<u>MEETING</u> PLANNING COMMITTEE
<u>DATE AND TIME</u> WEDNESDAY 26TH APRIL, 2017 AT 7.00 PM
<u>VENUE</u> HENDON TOWN HALL, THE BURROUGHS, LONDON NW4 4BG

**ADDENDUM TO SERVICE DIRECTOR OF DEVELOPMENT MANAGEMENT AND
BUILDING CONTROL'S REPORT**

17/0168/RMA

Application for Approval of Reserved Matter relating to the construction of the new Cool Oak Lane Pedestrian and Cycle Bridge as part of the West Hendon Estate Regeneration Scheme

Appendix 5 – Indicative Landscaping Proposal

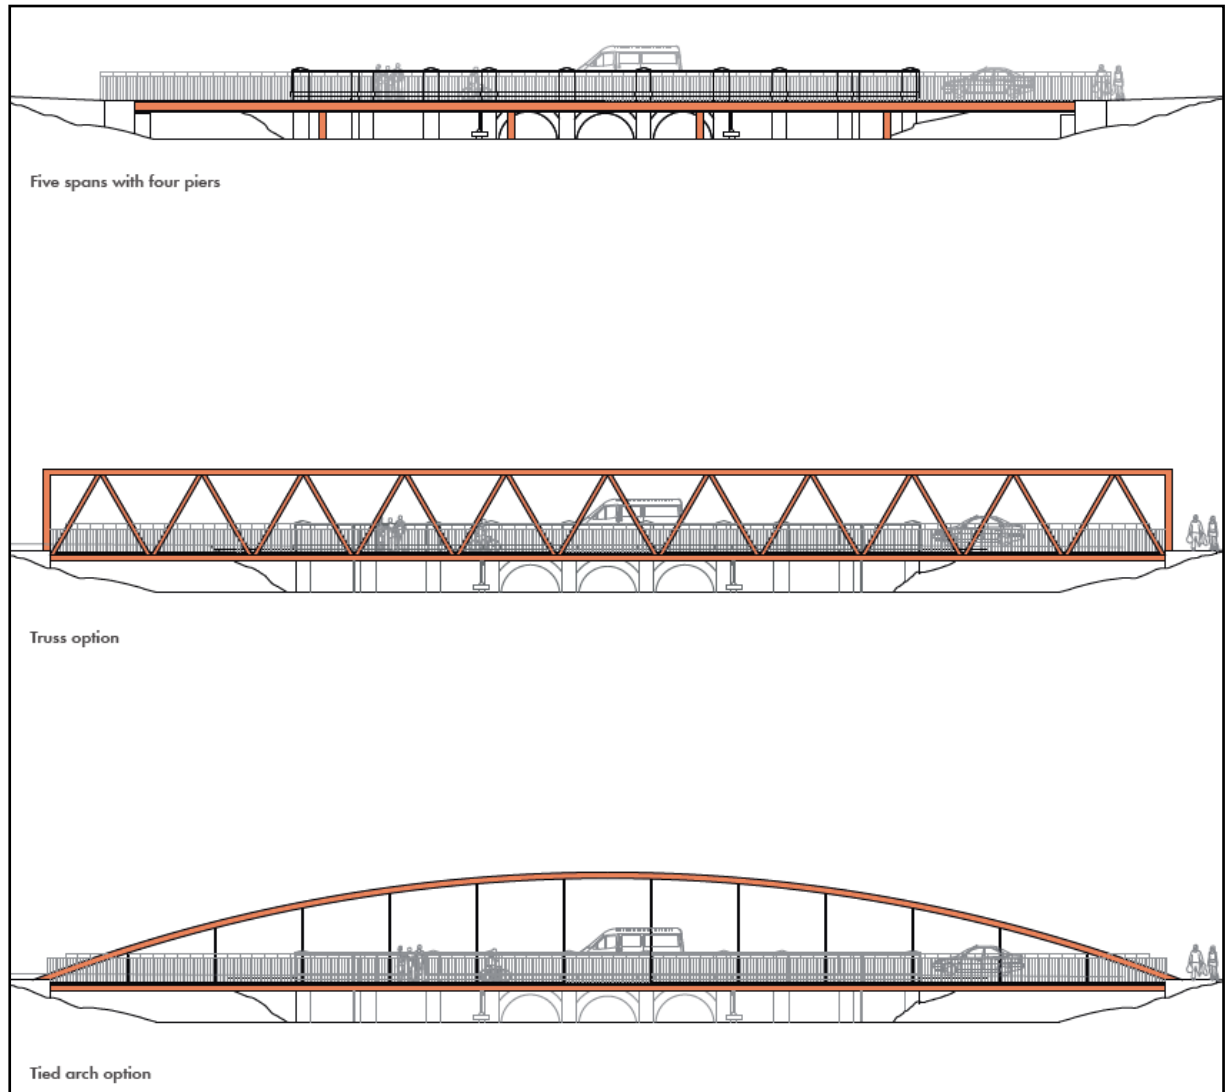
Whilst relocating the proposed bridge further north would avoid the loss of trees, the result would be a wider bridge span requiring a larger structure which would in turn have a greater impact on the adjacent heritage asset. The proposed bridge has been brought forward within the approved parameters established under the 2013 Permission. A condition is however recommended that will require the re-provision of four trees as part of a separate planning application that relates to the landscaped area to the east of the proposed bridge and as shown in Appendix 5.
